SUBJECT: NEW VEHICLE DEMONSTRATION / DELIVERY HOLD - Safety Recall 19S49
Certain 2020 Model Year Explorer/Aviator Vehicles Equipped with 3.0L Engines
Fuel Line Hard Contact

NEW VEHICLE DEMONSTRATION / DELIVERY HOLD - Safety Recall 19S49

CERTAIN 2020 MODEL YEAR EXPLORER / AVIATOR VEHICLES EQUIPPED WITH 3.0L ENGINES — FUEL HARD LINE CONTACT

FIGURE 1

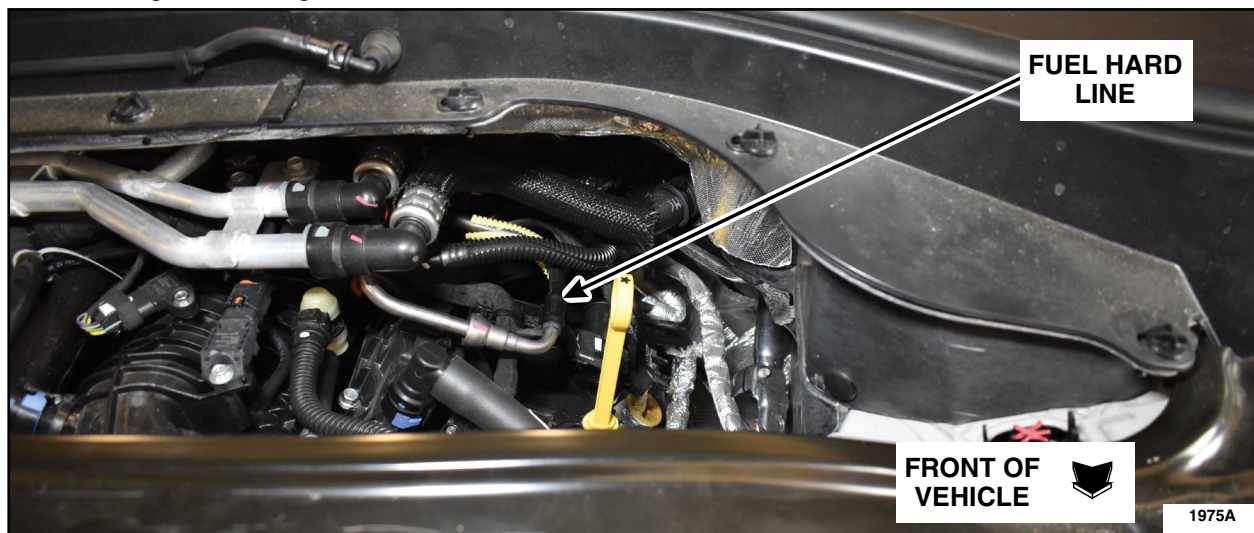
1. Open the hood.
2. Locate the fuel hard line and yellow protective sleeve, near the oil dip stick, on the Left Hand (LH) side of the engine. See Figure 1.

FIGURE 2

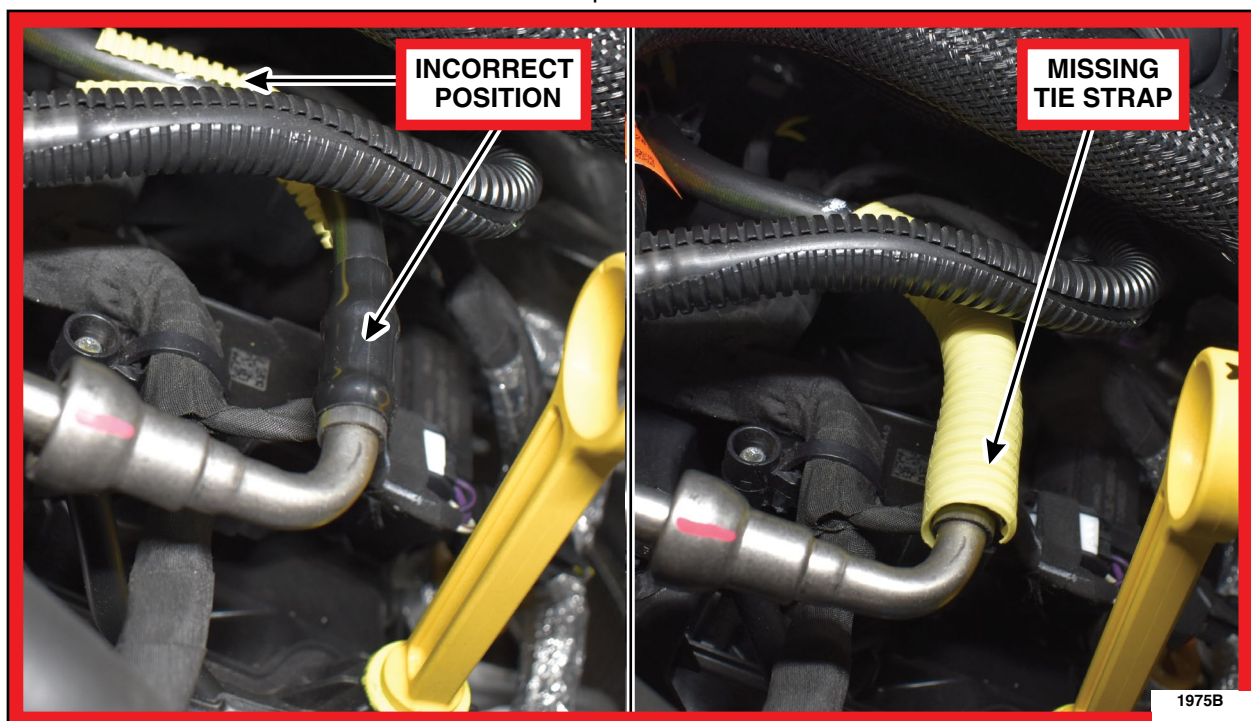
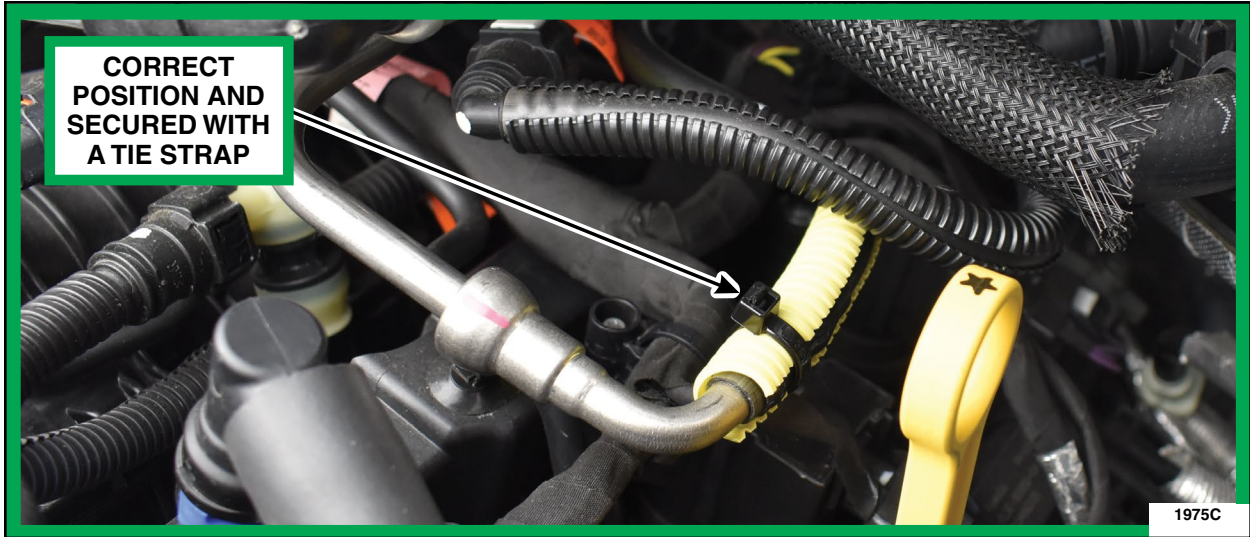
3. Measure the yellow protective sleeve:
- Is the yellow protective sleeve approximately 96mm (3.78 in) long?
 - Is the yellow protective sleeve properly located?
 - Is the yellow protective sleeve held in position by a tie strap?
 - See Figures 2 and 3.

NOTE: The short piece of convolute that requires replacement is 60mm (2.36 in), the longer piece is 96mm (3.78 in), and the difference between the two pieces is 35mm (1.38 in). Also the longer piece has a tie strap on it.

- If Yes to a, b and c above - This completes the recall.
- No - Obtain kit number L1MZ-9B149-AA and follow the instruction sheet number SKL1M3-9B149-AA for fuel line sleeve replacement.
